12B Spent Fuel Pool Geometry and Dose Rate Calculation

This Appendix provides ~~site-specific~~ information regarding the ~~Spent Fuel Pool (SFP) geometry and~~ methodology used to generate Spent Fuel Pool (SFP) radiation sources and dose rate assessments. ~~This Appendix supplements the SFP radiation source information in Section 12.2, specifically Tables 12.2-5a and 12.2-5b. See FSAR Section 12.2, Tables 12.2-5a, 12.2-5b, and 12.2-5c; and FSAR Section 12.3, Figures 12.3-5 through 12.3-10.~~

Figure 12B-1 ~~SFP Layout and Dimensions~~ Spent Fuel Pool Analytical Model

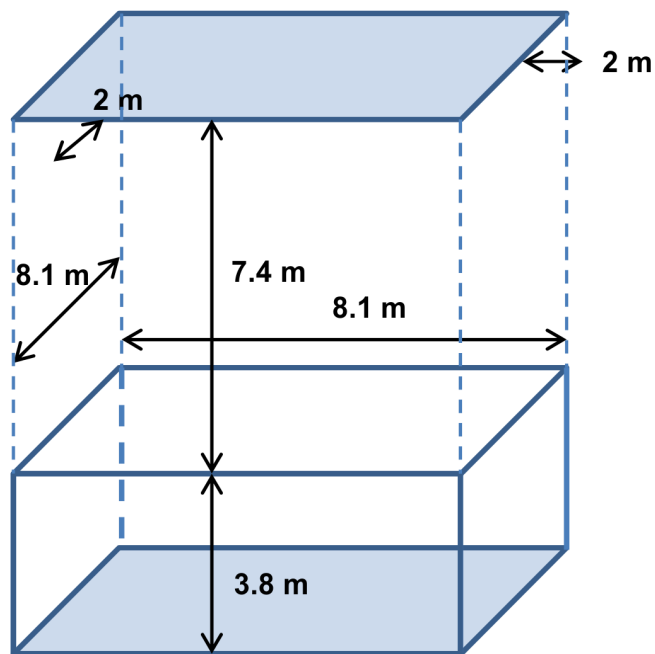
~~The SFP geometry is provided in FSAR Section 12.2, Tables 12.2-5a and 12.2-5b; and FSAR Section 12.3, Figures 12.3-6 and 12.3-10. The SFP storage rack has the capacity for 2365 BWR fuel assemblies. The size and configuration of the storage rack are given in Figure 12B-1, which shows an irregular rectangular cross section area extended to 10.7 m x 9.0 m. The fuel storage rack is situated at the lowest level of the SFP, where the total height of water is 11.6 m.~~

The SFP radiation source is used for the shielding design and analysis to ensure radiation levels at neighboring areas surrounding the SFP meet the design criteria. A simplified model of a rectangular parallelepiped of (8.1 m x 8.1 m x 11.2 m) is assumed to represent the SFP. The SFP peak radiation source is assumed to be homogenized over the bottom 3.8 m of the SFP to represent the active fuel length of a typical BWR fuel assembly. 3.8 meters was assumed to represent the height of the active fuel region, since this height results in the minimum required shielding of water. 11.2 m – 3.8 m = 7.4 m (see Table 12.2-5c). ~~There are 2 m thick concrete walls and floor surrounding the SFP on all sides. The floor of the SFP is~~ are 2 meters thick ~~as well (see Table 12.2-5c). The water shielding and distance between the spent fuel racks and the surrounding walls in the pool are not considered. (See Figure 12B-1).~~ The dose rate calculations are carried out with the point-kernel shielding code QAD-CGGP-A (Reference 12B.6-2). The calculated dose rate results indicate all the areas surrounding the SFP meet the reactor building (R/B) radiation zone limits. Figure 12B-2 shows the dose rate profile for a set of detectors along the centerline of the SFP perpendicular to the water surface. The ~~D~~ dose rate at the water surface is approximately 0.001 $\mu\text{rem/hr}$ ($1\text{E-}5 \mu\text{Sv/hr}$). The dose rates assessed are due to fuel assemblies in the SFP alone. Contributions from contaminants in the SFP water are not included.
